**Environmental Investigation
Plan
Cumberland Fossil Plant**

Revision 3 Final

TDEC Commissioner's Order:
Environmental Investigation Plan
Cumberland Fossil Plant
Cumberland City, Tennessee

REVISION LOG

Figure No.
1

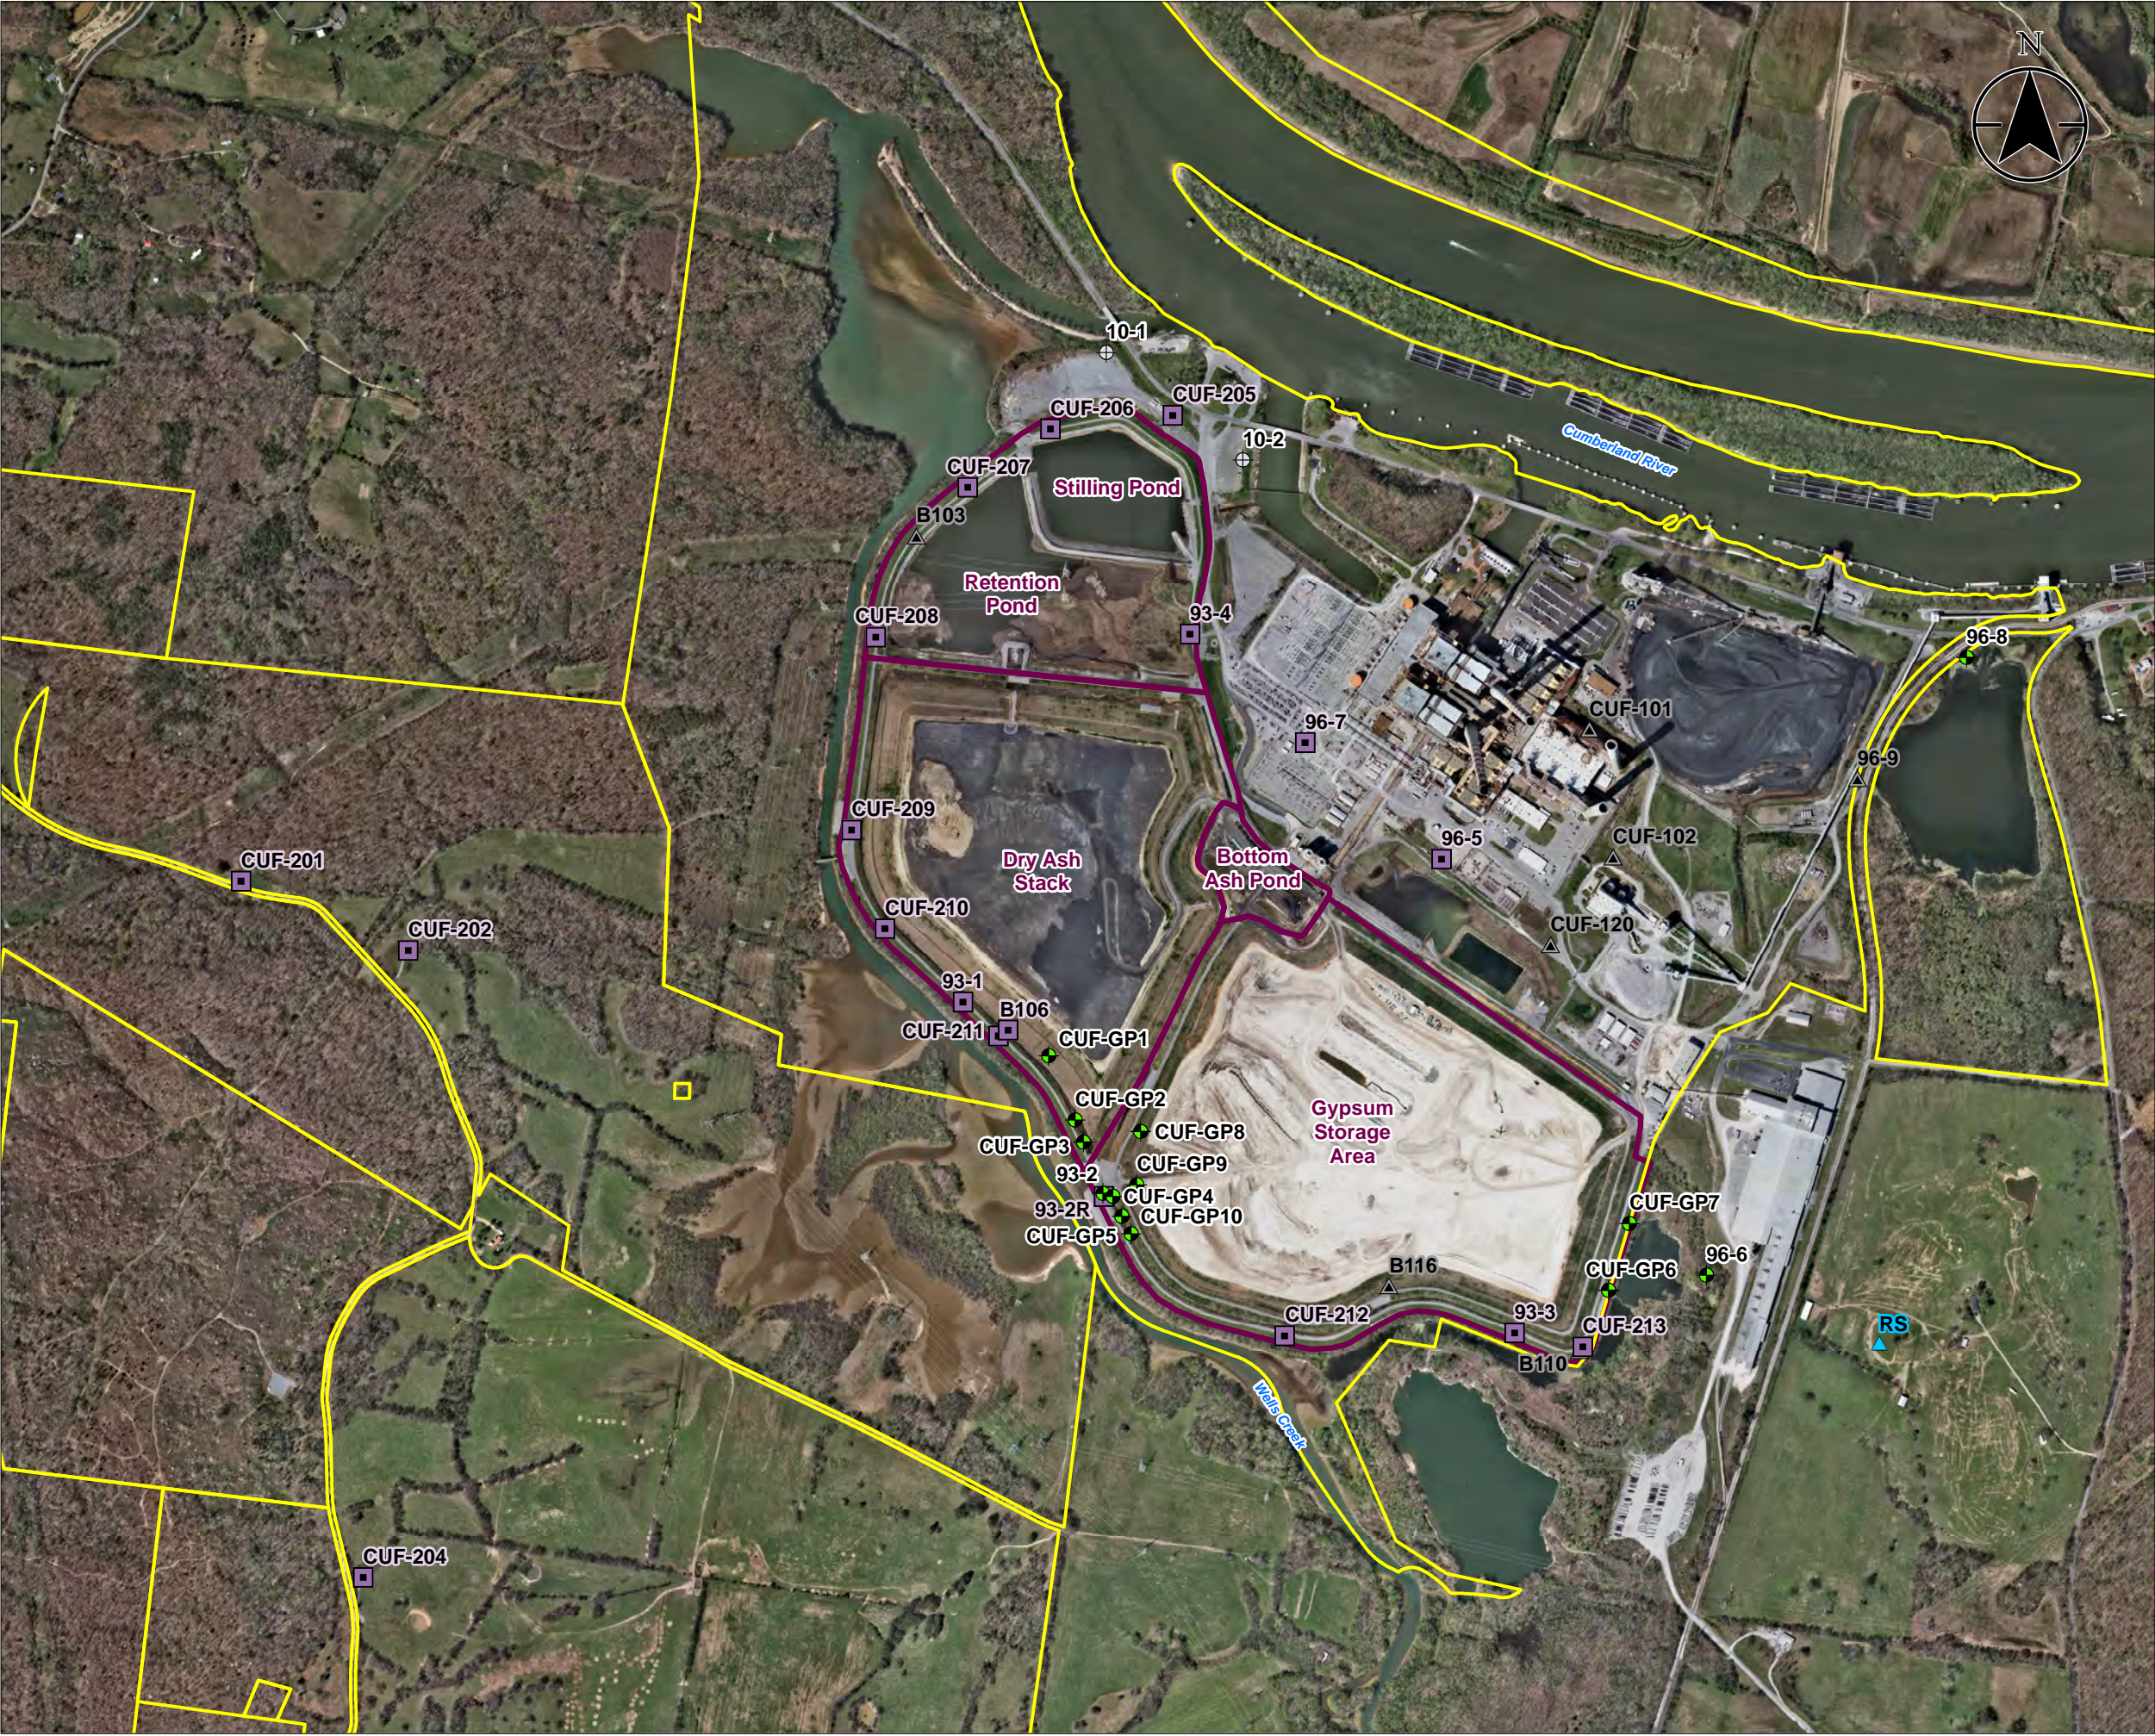
Appendix D	Figure 14	267/ 724	N.A.	N.A.	Provide additional Figure that indicates the location of all historical well that have been closed. Provide a copy of all groundwater monitoring optimization plans for the site that reference, discuss or document closure of wells. Provide the 2017 "Geotechnical Field Services for Well Installations and Closures, Groundwater Monitoring Optimization - Phase 3, Cumberland Fossil Plant, Cumberland City, Tennessee" dated February 10.
Appendix D	Figure 15	268/ 724	N.A.	N.A.	Add sediment sampling location in the proximity of the stilling pond discharge at the cooling water discharge channel.
Appendix D	Figure 19	272/ 724	N.A.	N.A.	Include documentation for the seep repair grouting at the Ash Pond referenced memorandum dated 11/20/1990 (B65901120029).
Appendix D	Figure 15 & 20	N.A.	N.A.	N.A.	Surface water and sediment sampling needs to be proposed for the embayment/pond in the northeast corner of the TVA property.

135	Appendix D	Figure 14	267/ 724	N.A.	N.A.	Provide additional Figure that indicates the location of all historical well that have been closed. Provide a copy of all groundwater monitoring optimization plans for the site that reference, discuss or document closure of wells. Provide the 2017 "Geotechnical Field Services for Well Installations and Closures, Groundwater Monitoring Optimization - Phase 3, Cumberland Fossil Plant, Cumberland City, Tennessee" dated February 10.	A figure showing the locations of historical wells that have been closed has been added as an appendix to the EIP. A copy of the Geotechnical Field Services for Well Installation and Closures dated February 10, 2017 has also been added as an appendix to the EIP.
136	Appendix D	Figure 15	268/ 724	N.A.	N.A.	Add sediment sampling location in the proximity of the stilling pond discharge at the cooling water discharge channel.	An additional sediment transect has been added at this location in the Benthic SAP.

Title
Existing Top of Rock
Elevation Boring Data

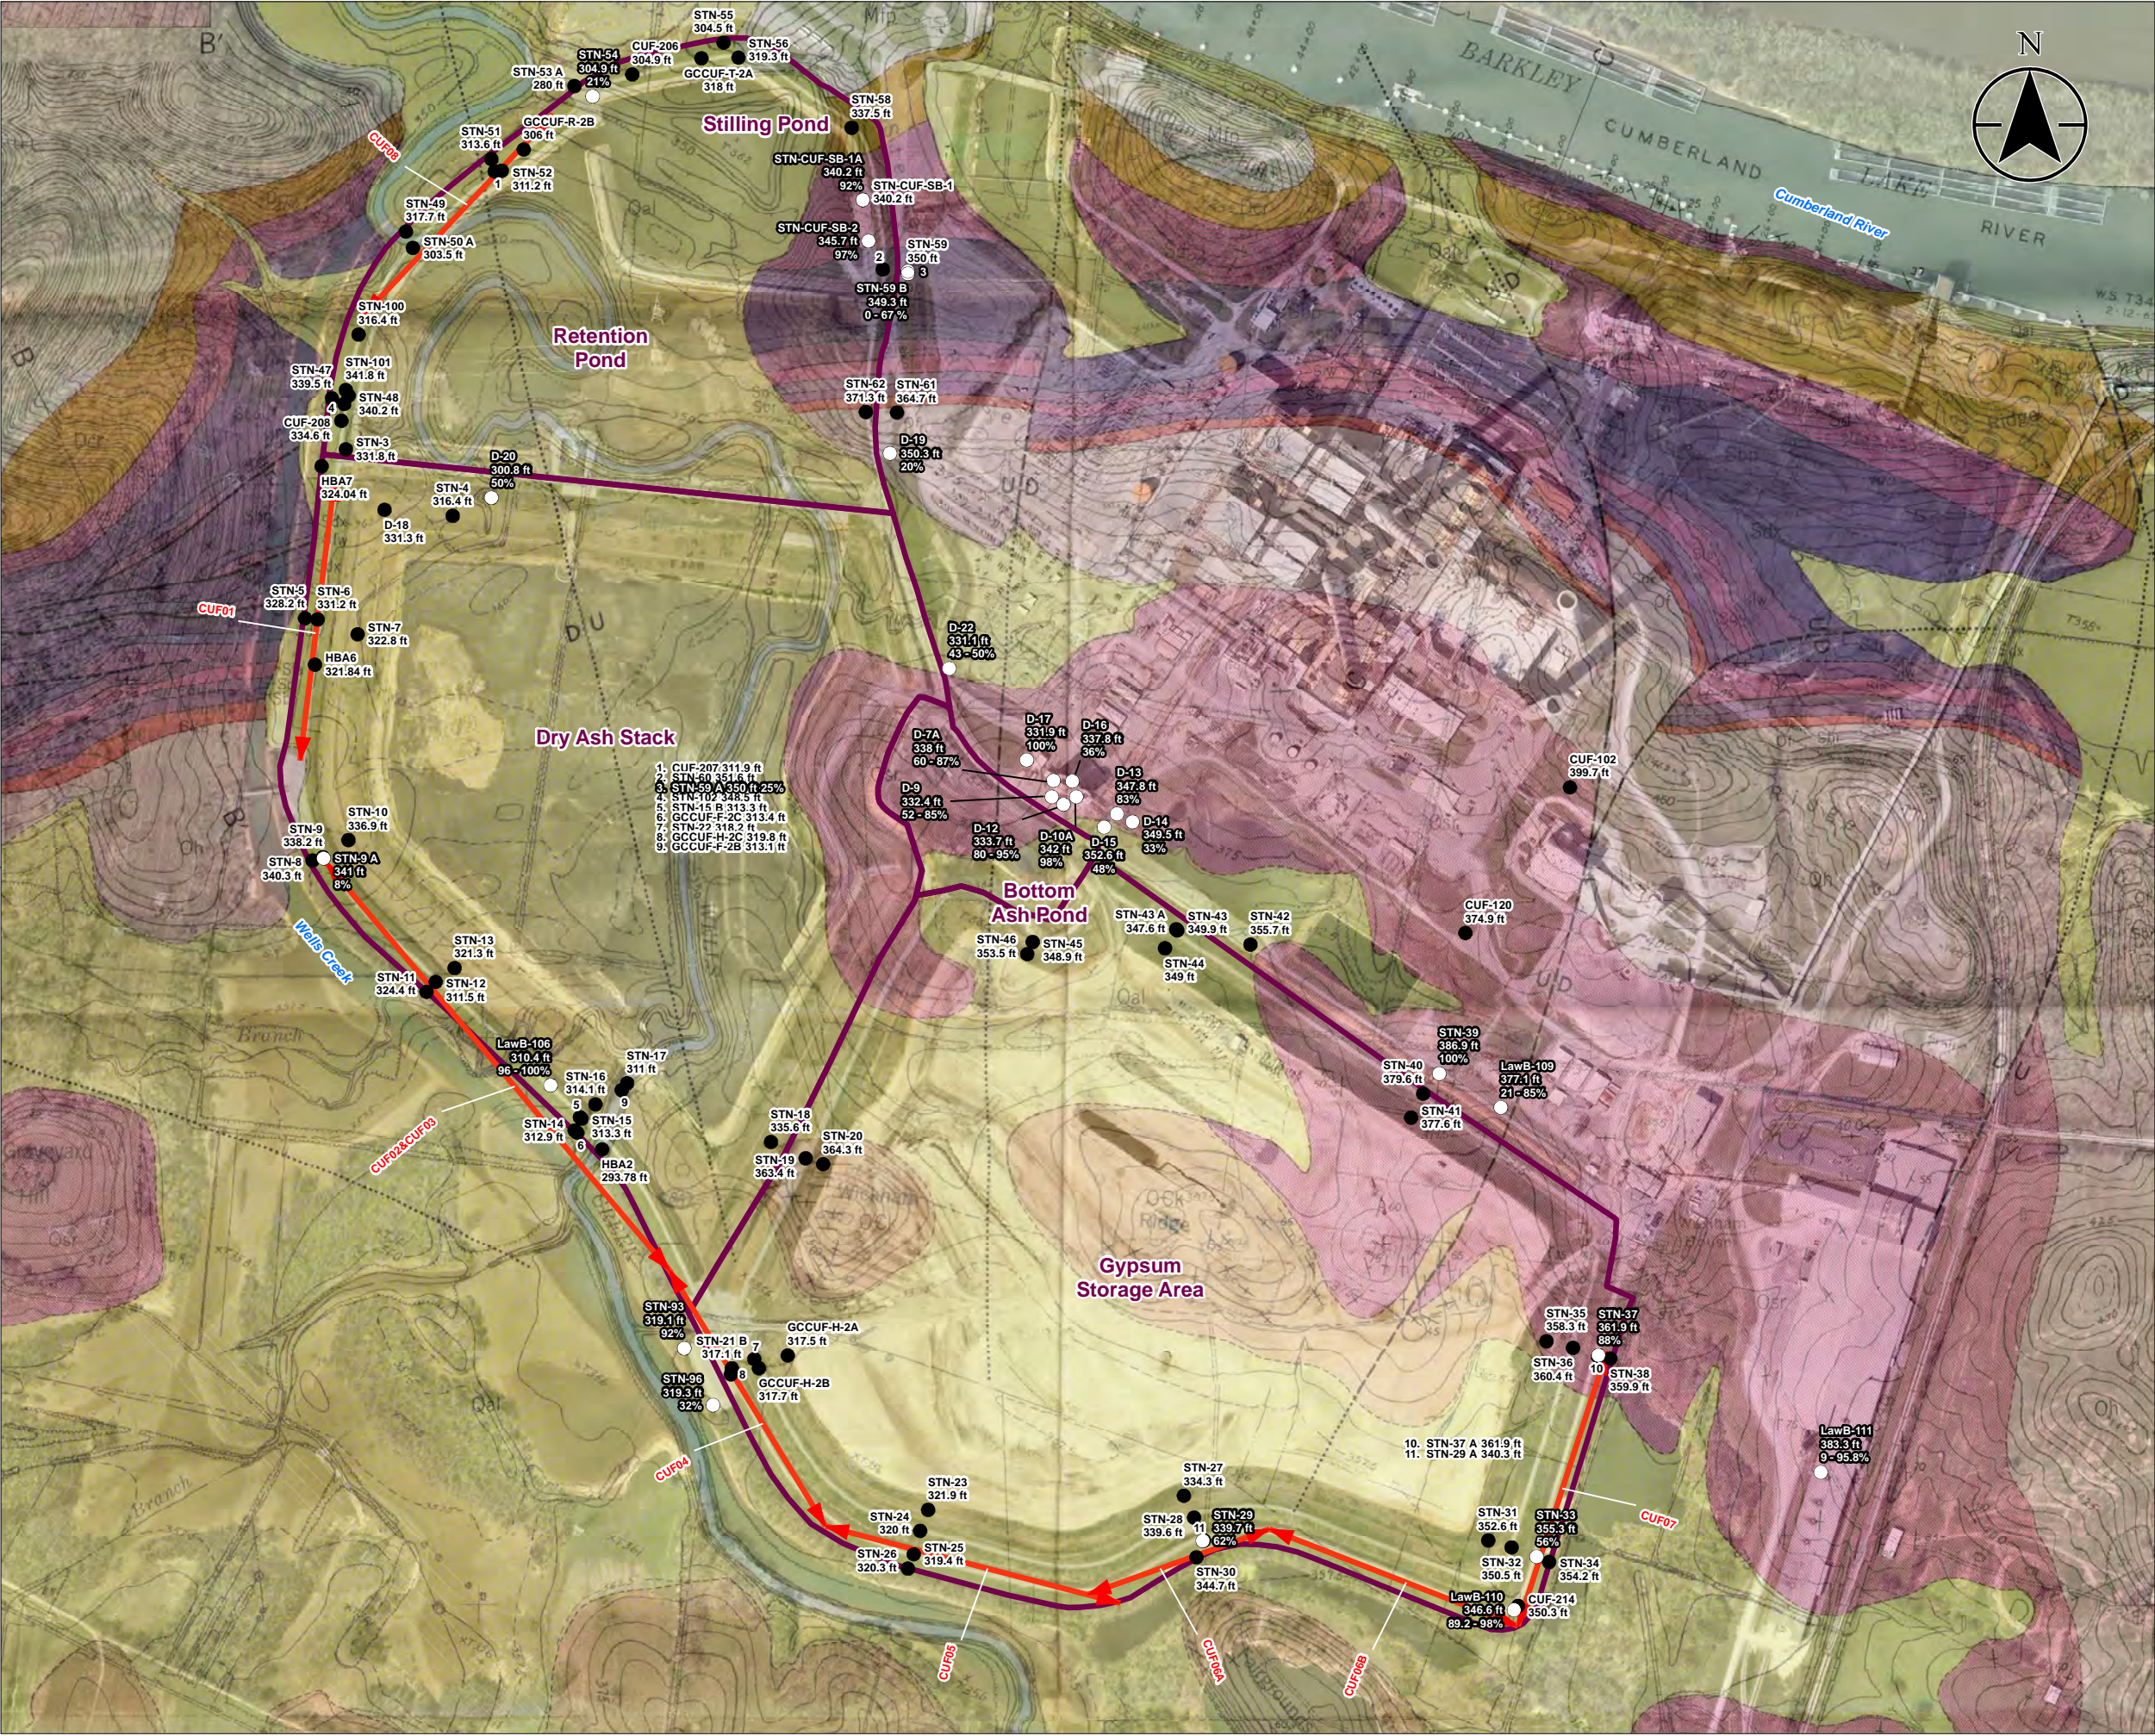
3.1.13	A.13 TDEC Information Request	24	NA	NA	Stability of bedrock below fill areas - The EIP discusses the installation of 13 borings in the area of the stilling pond and the landfill. Will these borings provide enough additional information to adequately determine the stability of the rock structure below? - see Figure 1 Adobe Page 423

Comment Number	Section Number	Section Title	Page	Paragraph	Line	TDEC Comment (August 31, 2017)	TVA Response (November 9, 2017)
41	3.1.13	A.13 TDEC Information Request	24	NA	NA	Stability of bedrock below fill areas - The EIP discusses the installation of 13 borings in the area of the stilling pond and the landfill. Will these borings provide enough additional information to adequately determine the stability of the rock structure below? - see Figure 1 Adobe Page 423	As noted in Section 3 of the EIP, the proposed borings are not, by themselves, intended to assess bedrock stability. Instead, the proposed borings are intended to be used in conjunction with existing geotechnical and hydrogeologic data, surface geophysics, geologic mapping/characterization, and visual inspection reports. The proposed borings, when used as part of this broader data set, are sufficient to respond to the information request.

41	3.1.13	A.13 TDEC Information Request	24	NA	NA	Stability of bedrock below fill areas - The EIP discusses the installation of 13 borings in the area of the stilling pond and the landfill. Will these borings provide enough additional information to adequately determine the stability of the rock structure below? - see Figure 1 Adobe Page 423	As noted in Section 3 of the EIP, the proposed borings are not, by themselves, intended to assess bedrock stability. Instead, the proposed borings are intended to be used in conjunction with existing geotechnical and hydrogeologic data, surface geophysics, geologic mapping/characterization, and visual inspection reports. The proposed borings, when used as part of this broader data set, are sufficient to respond to the information request.	TVA shall collect sufficient data during the installation of the 13 borings described in Section 3.1.13 that it can be used in the calculations of bedrock stability.
